32 Brookside Avenue
Block 14, Lot 759.02
Borough of Demarest, Bergen County, NJ
Joint Land Use Board Application - Engineering Review
Colliers Engineering & Design Project No. DEZ0046

Engineering Review

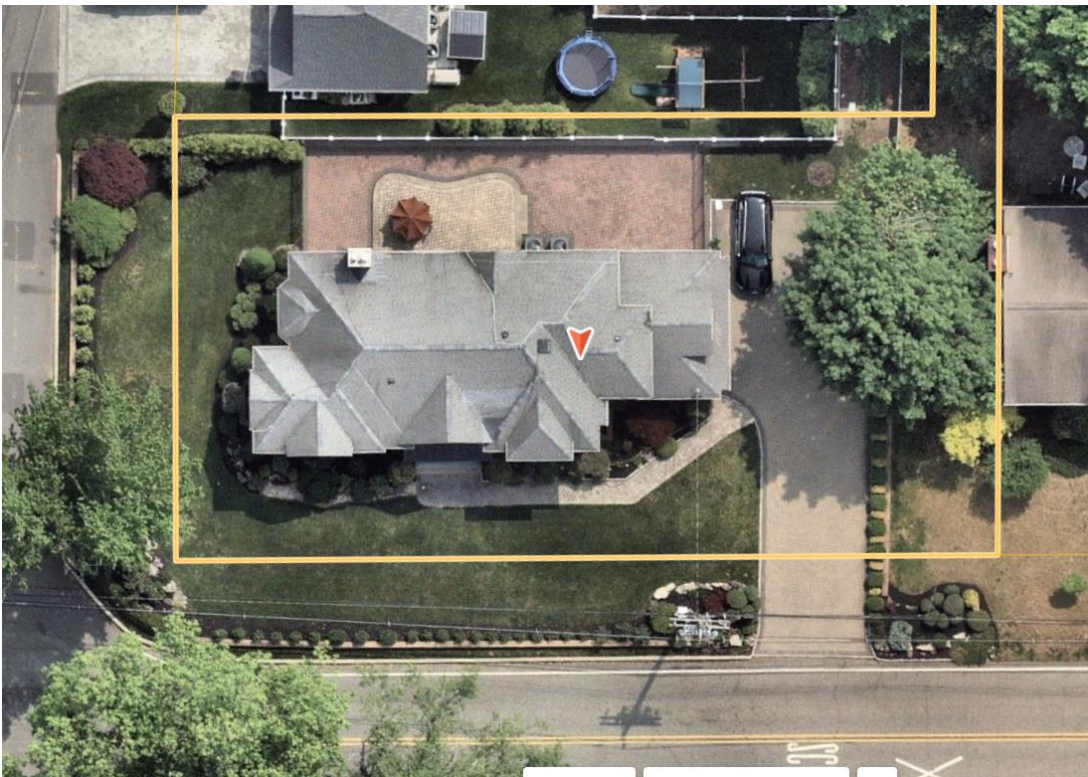
- A. The survey should be updated to provide a zoning table showing all existing setbacks and coverages.
- B. The Applicant has submitted a survey of the previously constructed improvements. Based on the survey, it is unclear if there are any existing drainage improvements or stormwater measures on the site. The Applicant should provide testimony if there are drainage improvements on site. In addition, drainage calculations should be provided verifying the sufficiency of any stormwater measures constructed.

1. There is a retaining wall constructed within Borough ROW along the Serpentine Road and Brookside Avenue frontages. The wall is approximately 175 feet long and appears to be decorative. The Applicant should provide testimony as to the need for this wall. We recommend the wall is removed unless sufficient evidence is provided to justify it remaining.

2. There is a retaining wall constructed along the southern property boundary adjacent to the driveway. Top and bottom of wall elevations have not been provided. Google imagery suggests that the wall is approximately 1-2 ft high. The Applicant should confirm in testimony. A portion of this wall encroaches into Borough ROW and should be removed.

3. There appears to be a wall located along the eastern property boundary which is not labeled on the survey. Top and bottom of wall elevations have not been provided. The Applicant should provide testimony to clarify.
